From: Paola M. Ferrer, Esq. <pmferrer@gmail.com>
Sent: Friday, February 9, 2018 4:56 PM
To: Strysky, Alexander (EEA)
Subject: MassPike Allston DEIR Comments EEA#15278

We respectfully submit this letter as homeowners/residents of Allston in response to the Draft Environmental Impact Report (DEIR) submitted by MassDOT for the reconstruction of the Mass Pike, and to request you require a Supplemental DEIR to optimize the positive impact of the project.

RE: Comments on DEIR Allston I-90 Interchange Project

RIVER STREET BRIDGE

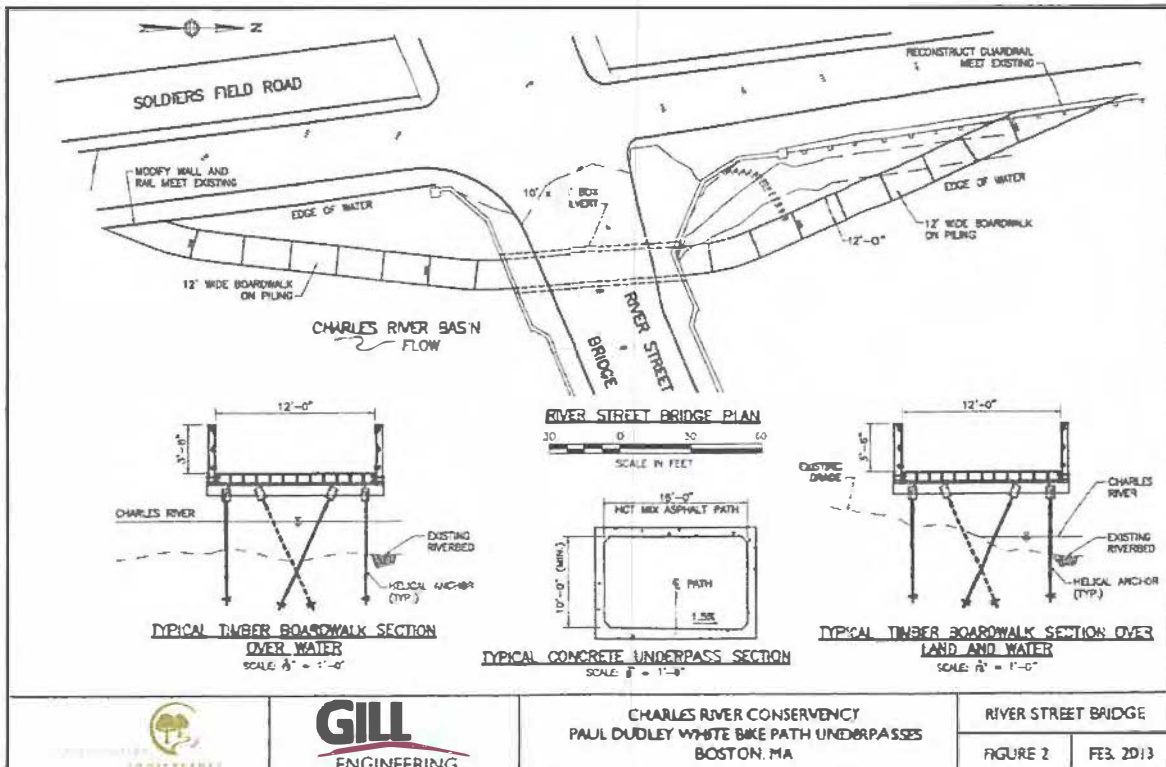
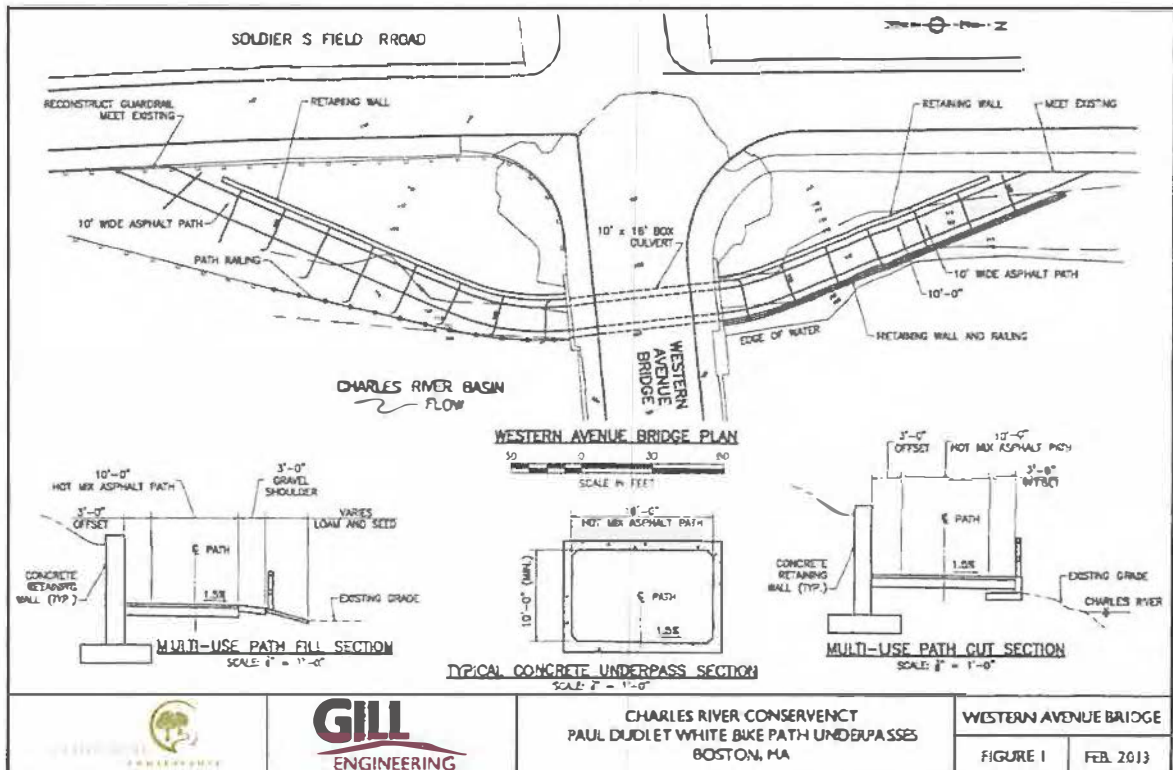
5. Include pedestrian/bicycle underpasses in reconstruction of River Street and Western Avenue Bridges. Reconstruction of these bridges should be part of the above system study and should include pedestrian/bicycle underpasses on the Boston side of the Charles River. An underpass under the Andersen Memorial Bridge is currently under design, with 25% drawings having received endorsement from the Massachusetts Historic Commission. Adding underpasses to River Street and Western Avenue bridges would complete an uninterrupted DCR pathway system under the Longfellow, Massachusetts Avenue, Boston University, and Eliot Bridges all the way to Watertown. The Charles River Conservancy has developed engineering plans and design renderings of underpasses for River Street and Western Avenue Bridges (attached), and should be considered in designing the reconstruction of both bridges.

CUT/COVER PROPOSAL

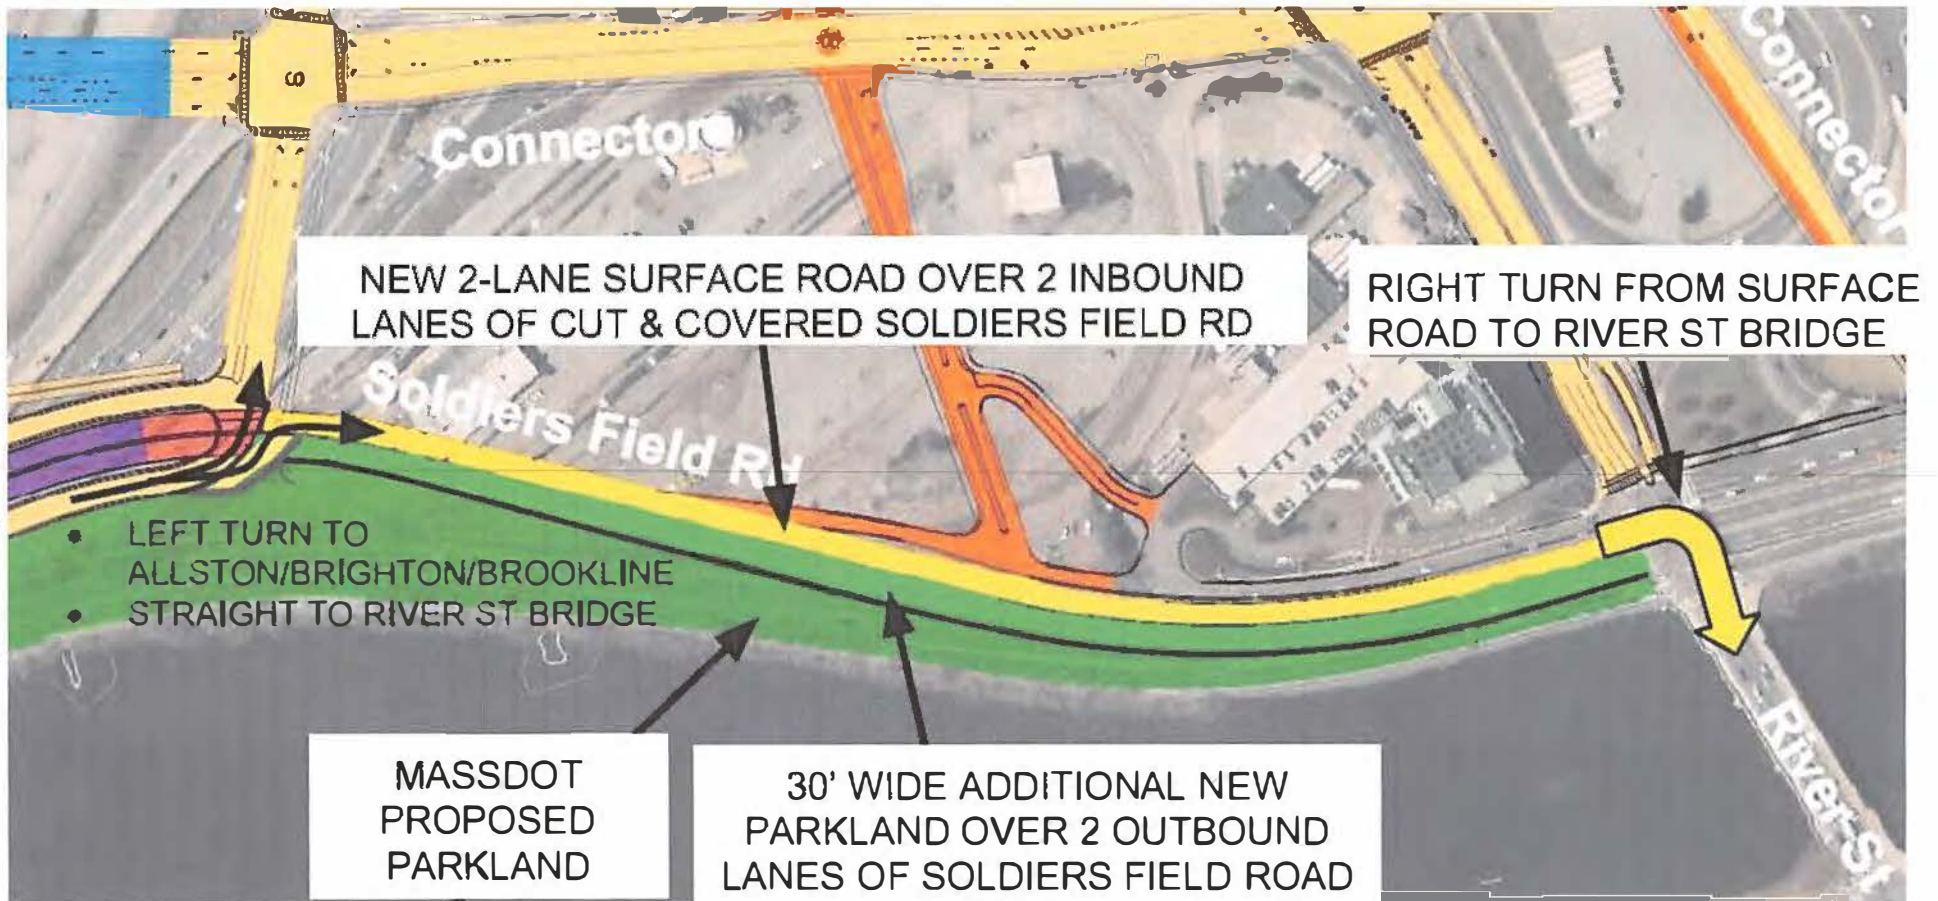
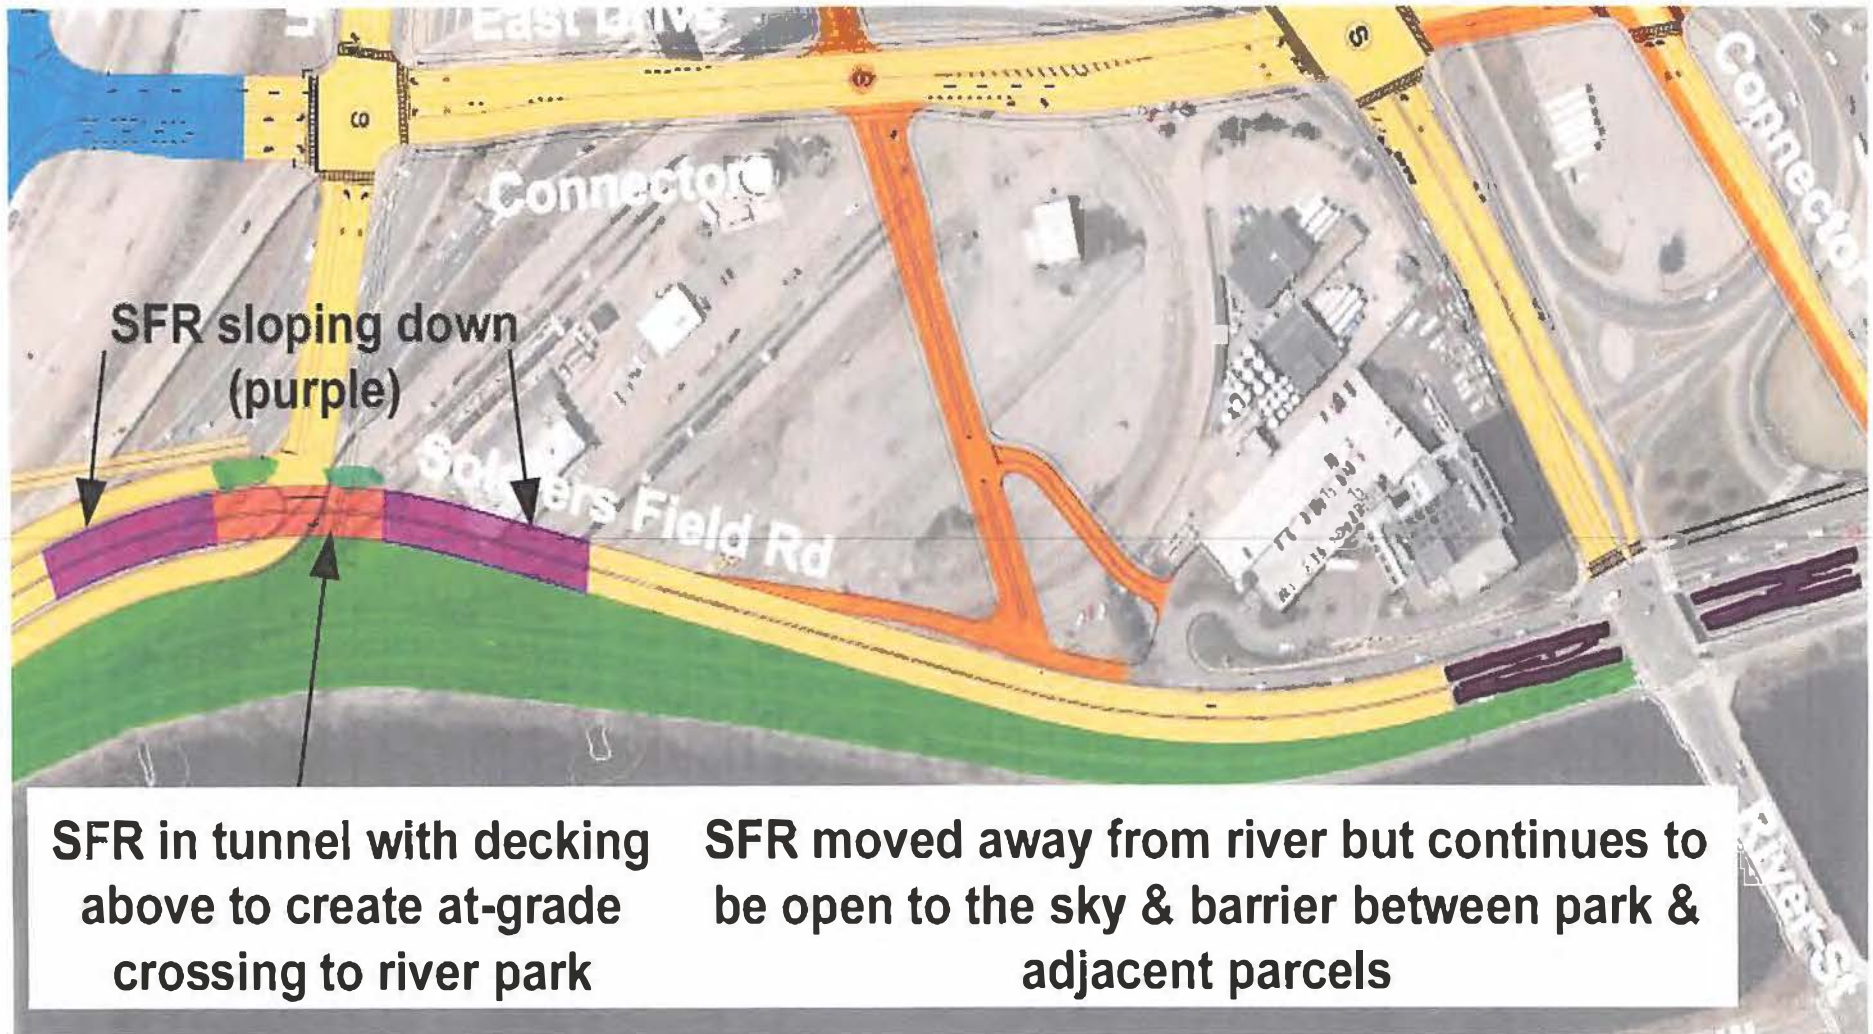
6. Consider continuing a below-grade SFR beyond River Street Bridge. A plan (attached) to rebuild SFR below-grade from its proposed underpass at Cambridge Street to the existing underpass under River Street Bridge was submitted to MassDOT for consideration in the I-90 DEIR, but it was not analyzed and has not been included. We believe that plan is worth further study. It would lower SFR and, with approximately 1,600 feet of additional decking, cover it with parkland, expanded pathways, and a narrow surface roadway that would provide direct access for a right-turn only to Cambridge. The resulting parkland would be many hundred feet longer than the very short pedestrian/bicycle crossing provided at the Cambridge Street South SFR underpass and therefore provide easy access to the riverfront across the decking. This expanded parkland would benefit the new Harvard developments as well as current residents and others who enjoy the parklands by the river. And the roadway would provide a "local" street that pedestrians could cross safely while at the same time letting traffic heading to Cambridge make the right-turn onto the River Street Bridge.

River Street Intersection

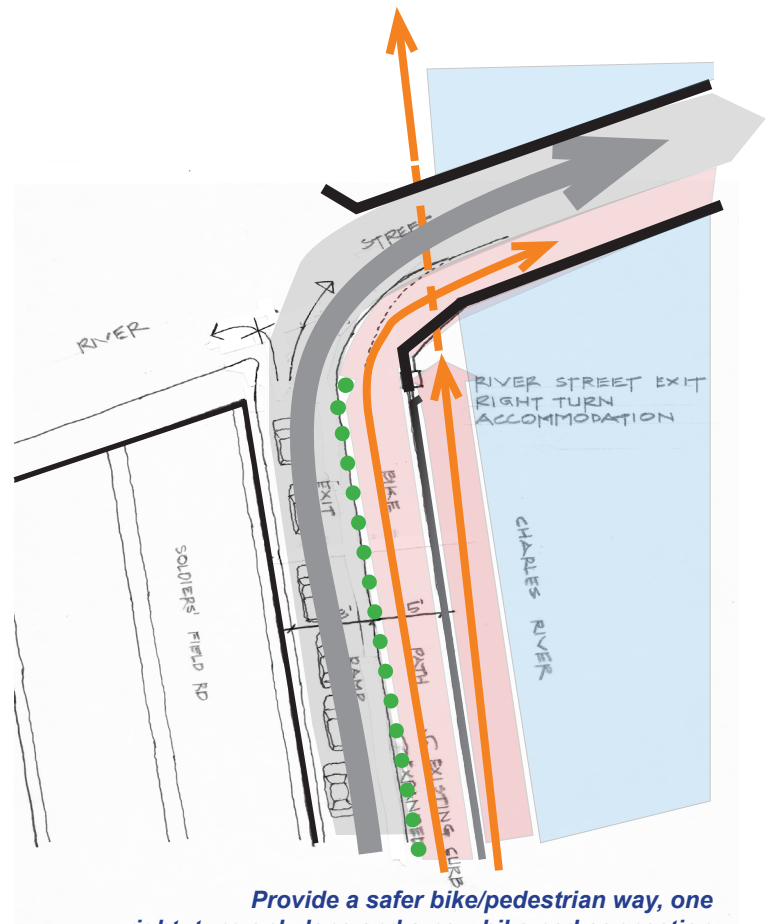
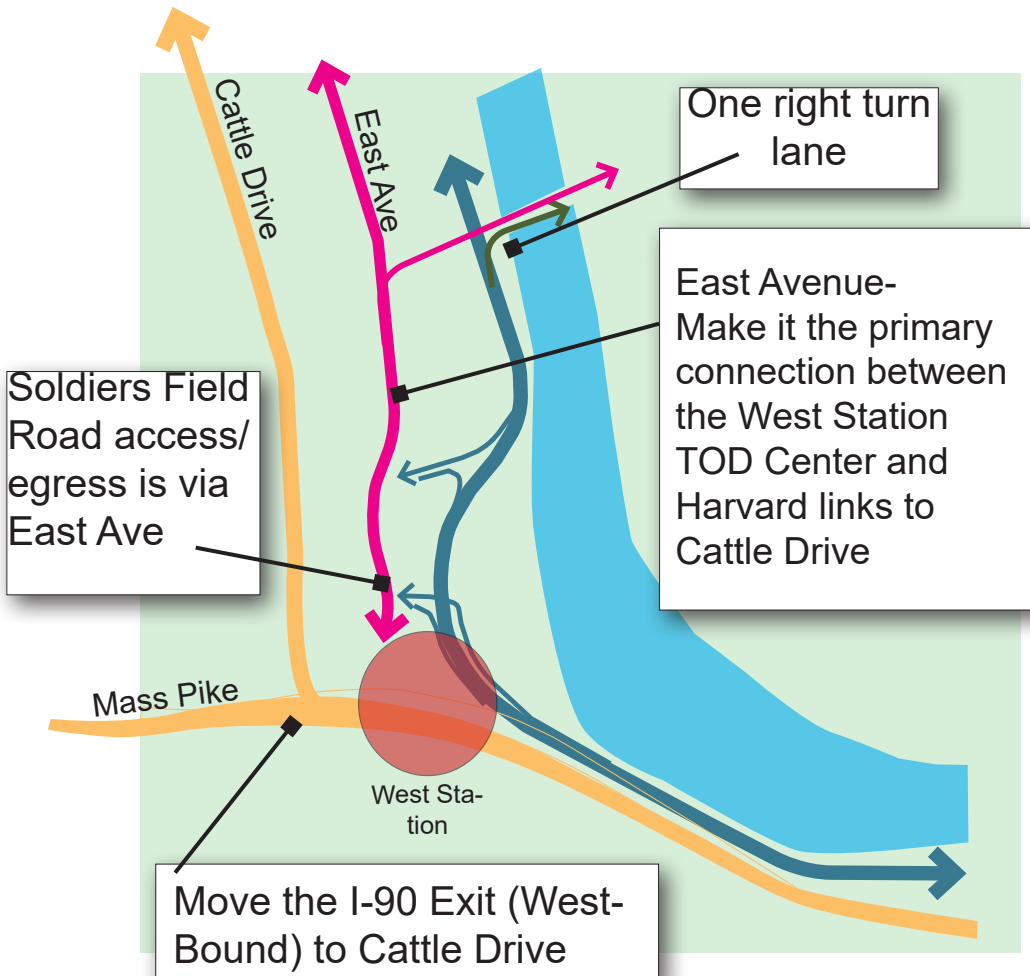
While MassDOT's current recommendation to remove the west-bound off-ramp altogether appeals to bikers and park lovers, this is also a major access point for drivers into Cambridge. Two improvements could ease this situation and allow a single right-turn-only off-ramp to remain:

1. The Charles River Conservancy proposes a bike/pedestrian passage under River Street. Most bikers and pedestrians would then be safely separated from right turning vehicular traffic, thus facilitating these right turn movements for motorists. Since this bridge is in poor repair and in need of reconstruction, this project should dovetail closely with MassDOT's planned Allston I-90 improvements.

Provide a safer bike/pedestrian way, one right-turn-only lane and a new bike ped connection under the River Street Bridge
